UI comments, 2025-05-03

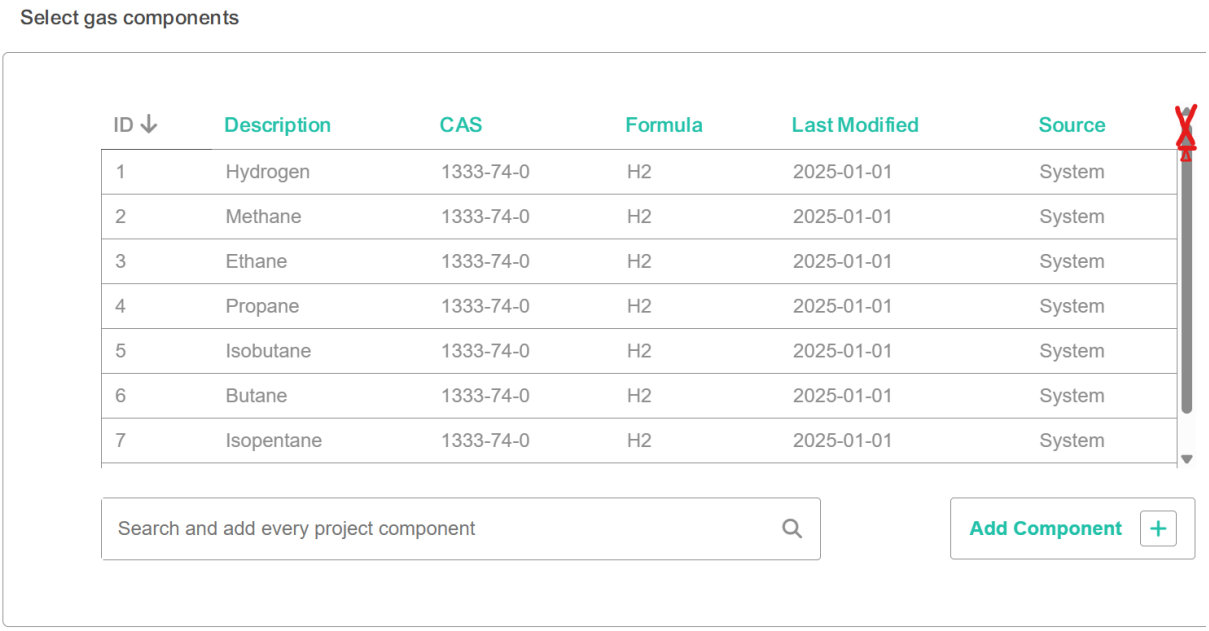
1. Gas components vertical scroll is including the table header which was not the intended behavior. Please change vertical scroll inclusion to only include the list of components:

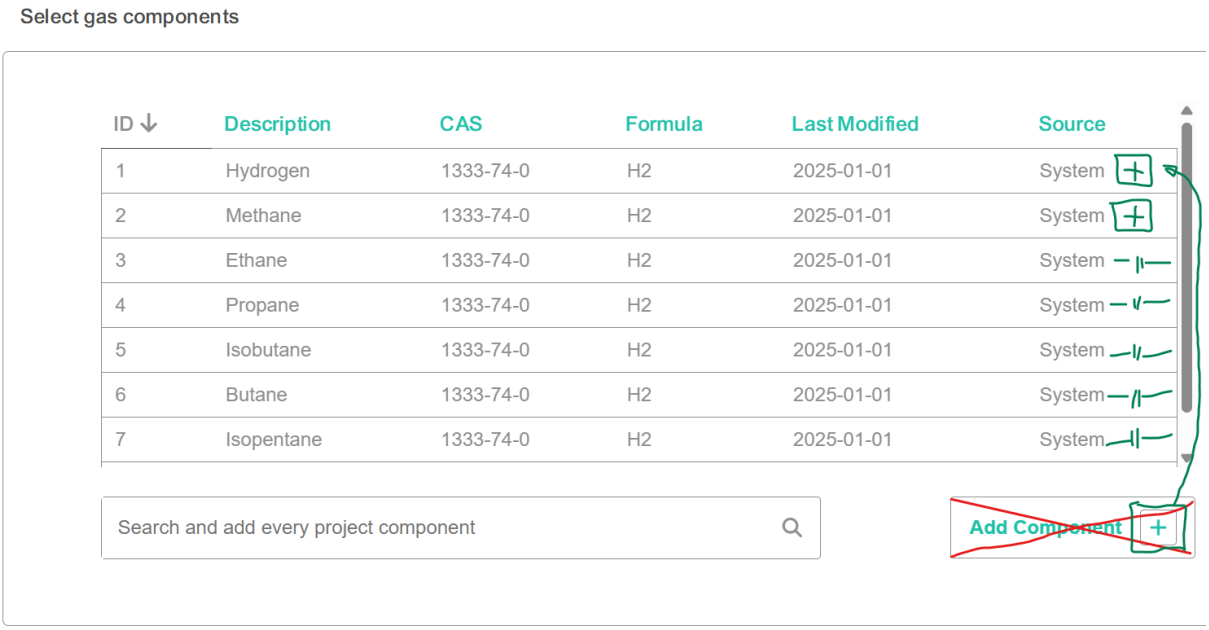
2. Gas components button for “Add component” was intended to align with the table right border – not the vertical scroll right border. However, I think this button can be excluded completely since I like your solution where a clicked component item is immediately added to the list of “Selected component(s)” – hence, removal of “Add component” button is preferred if “add icon” is added to each row in the table:

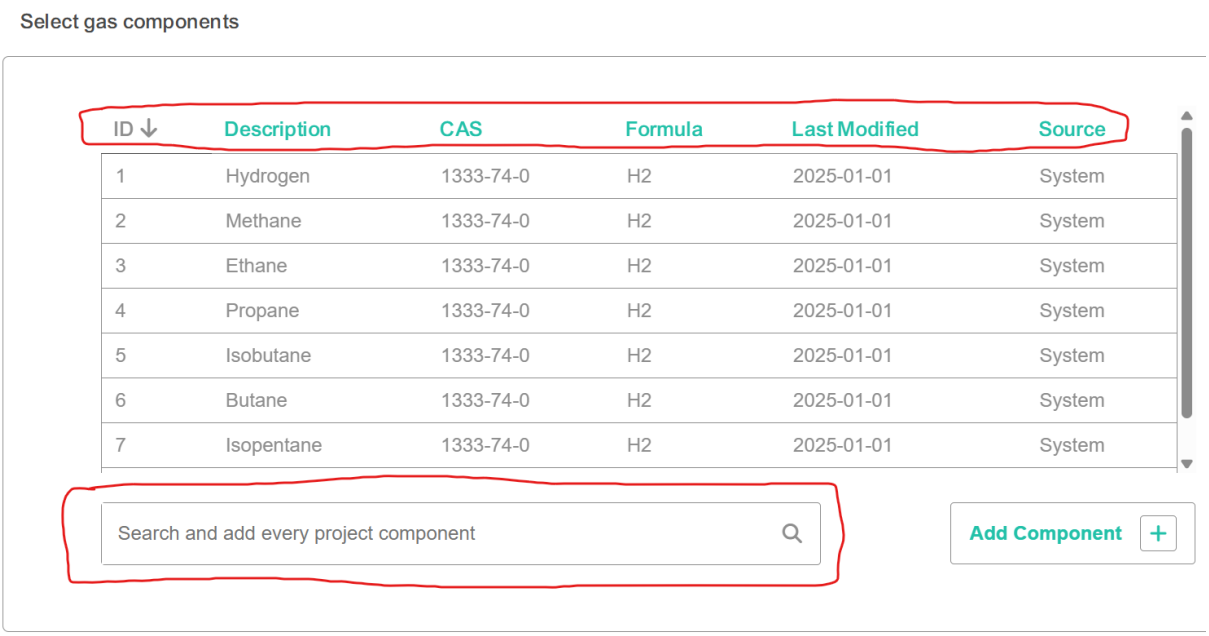
3. Javascript sort and search/filter function for “Select gas components” is not functional:

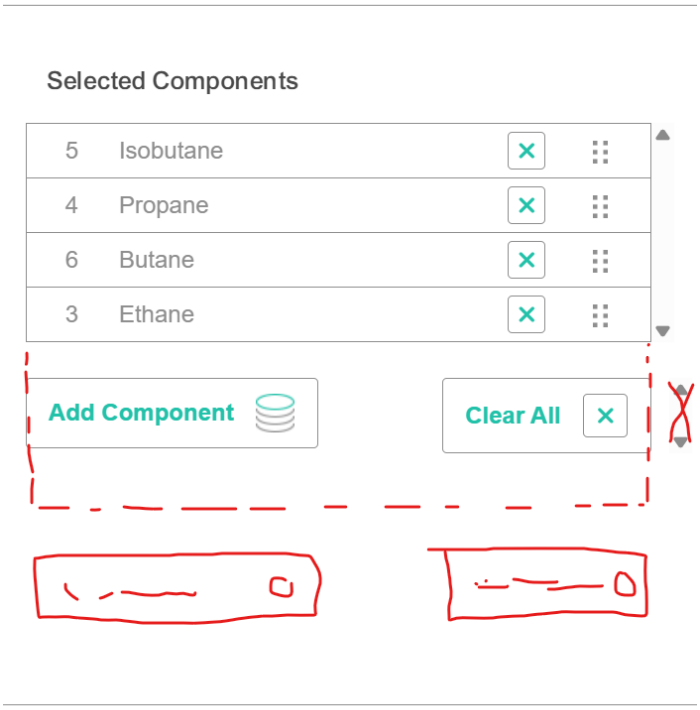
4. Selected components should have a container with fixed height to avoid vertical movement of buttons “Add component (((change to “Load from library” as per PSD)))” and “Clear all” depending on how many component items are added in the list, also refer to PSD and remove vertical scrollbar for the buttons:

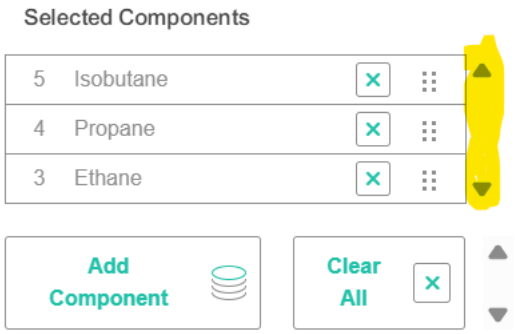
5. Scrollbars shall only be shown when they are needed, i.e. when more information are listed than what is visible in container vertical height:

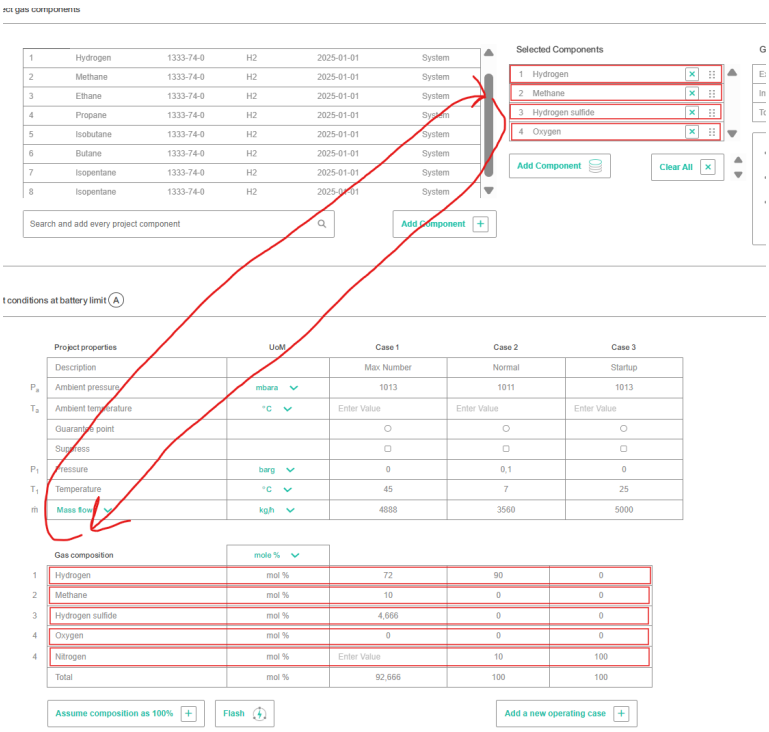
6. When the position of a “selected component” is changed by user drag N drop, the order of the components shall also be updated in the “Gas composition” section as it should always match with the order of “selected components” – that is the whole purpose of the function to allow order change of components:

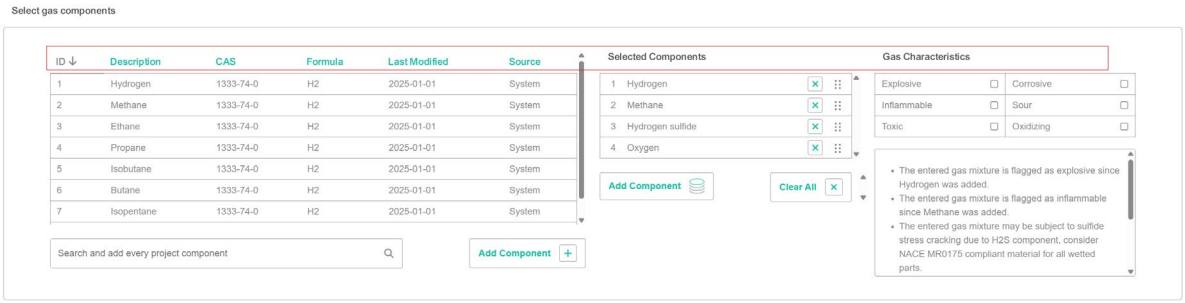
7. Inconsistent header sizing – headers outside the grey border container shall be a size and headers inside the grey border container shall be a smaller size.

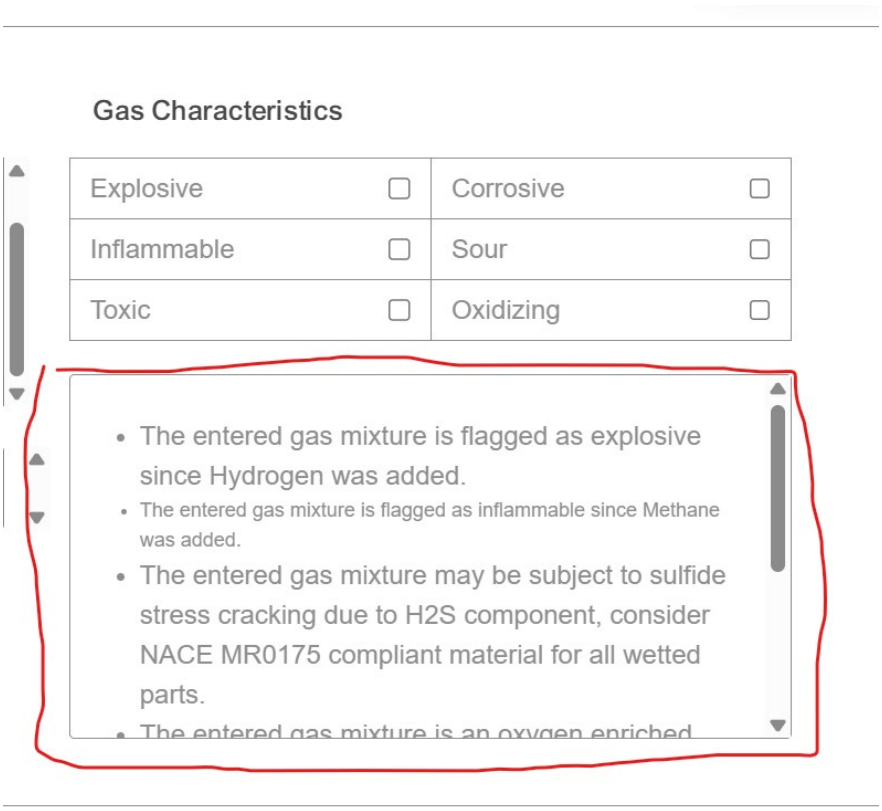
8. Make the Gas characteristic notes text less significant, perhaps smaller font-size or similar:

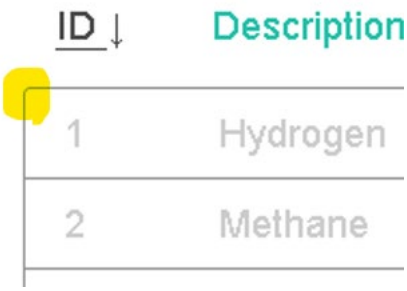
12. Container corners are not matching well with PSD design. It shall be round corners, see example:

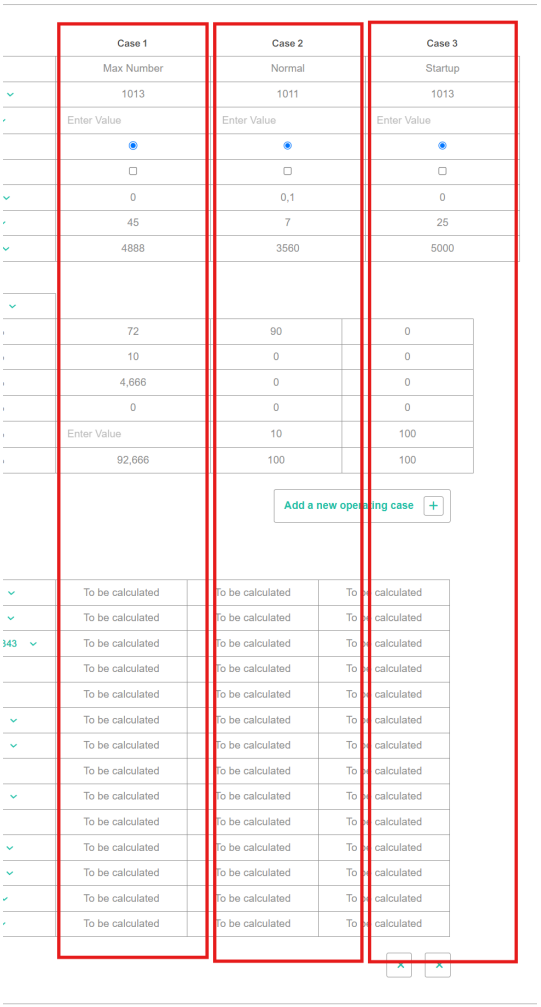
13. Project properties radio button, not check mark (!!!) – only one shall be selectable as guarantee point:

14. Project input and property columns need to align at all times as they are essentially the same column (!!!):

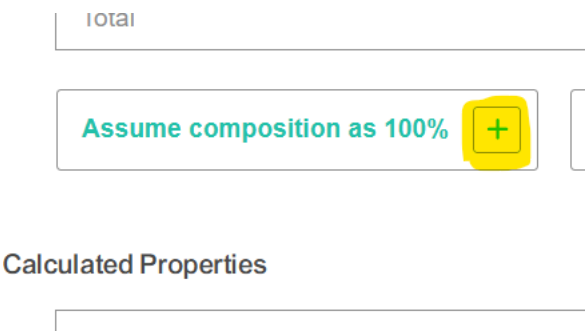
15. This should be a check box button. Refer to PSD:

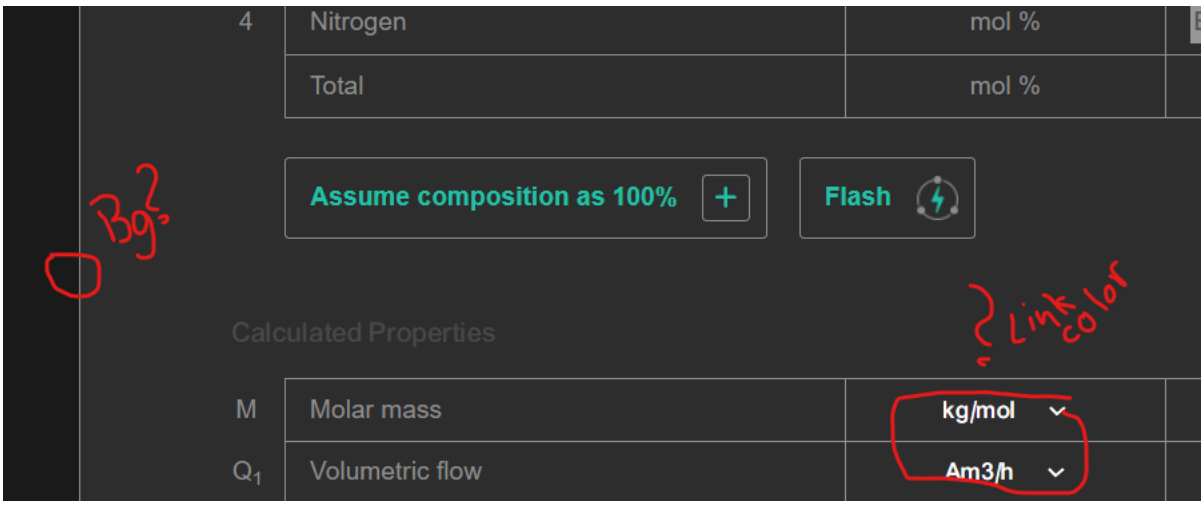
17. Dark theme strange look by some items having a background, the “green” link color is for some reason removed from some items like drowndown lists? Please work a bit more on the dark theme…

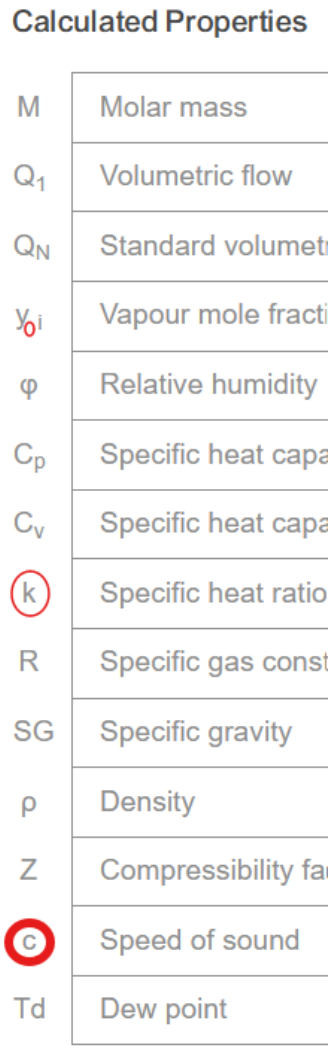
21. Symbols of calculated properties are not matching with PSD. Please consider to use Times New Roman for these symbols to better clarity/look. For specific heat ratio it should be κ and not normal k. Please remove “space” between y and i:

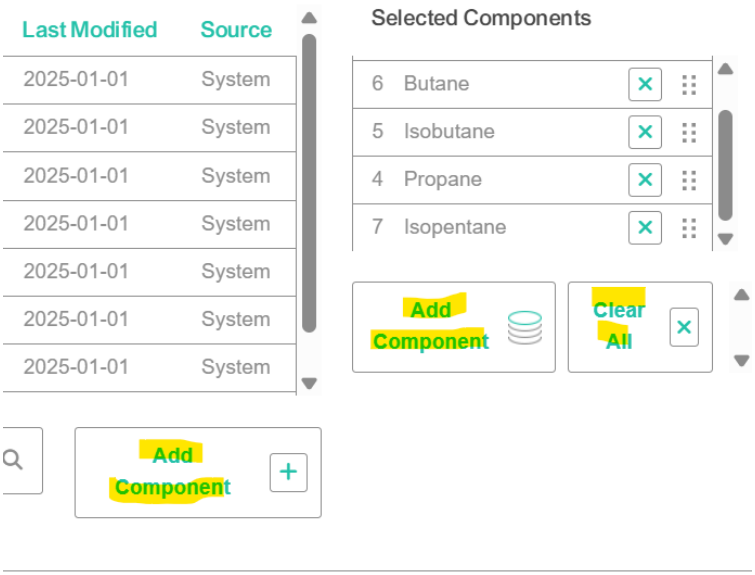
22. Some buttons behave strange and breaks line during resolution change:
